From: Adam Rothwell
Sent: Tuesday 16 June 2026 15:05
To: Samuel Uff; Elisabetta Tonazzi; Chris Hill
Cc: Eduarda Vieira; Steve Eldergill; Niall Tallis1; John McRory; Jade Pleass; Harry Nahum; Harringey Dalux Archive; Liz Pickard; Gwyn Williams
Subject: Civic Centre On-Site Recurring Meeting - 11th June meeting minutes
Attachments: Haringey Civic Centre - Draft Lobby Canopy Survey.pdf; HCC-CTF-ZZ-00-DR-L-100000.pdf; 556-CTF-XX-XX-PR-L-0008_Paving presentation_CTF proposal.pdf

External lobby doors to civic centre

Paint to 3rd Floor to Match GRC

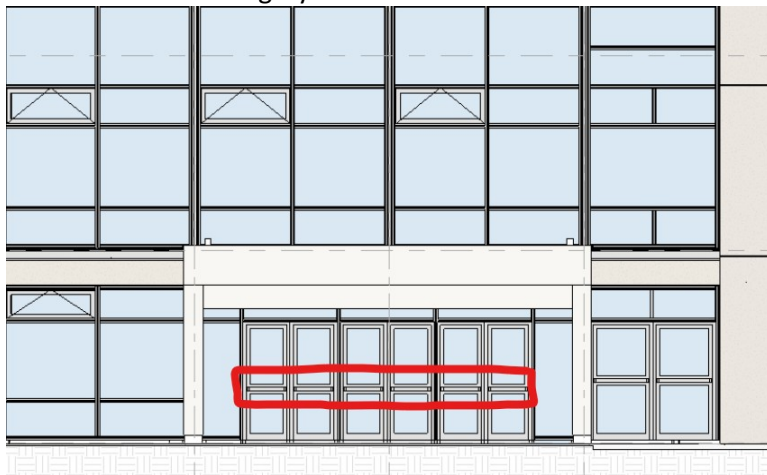
5. Sandstone is the best match see below.
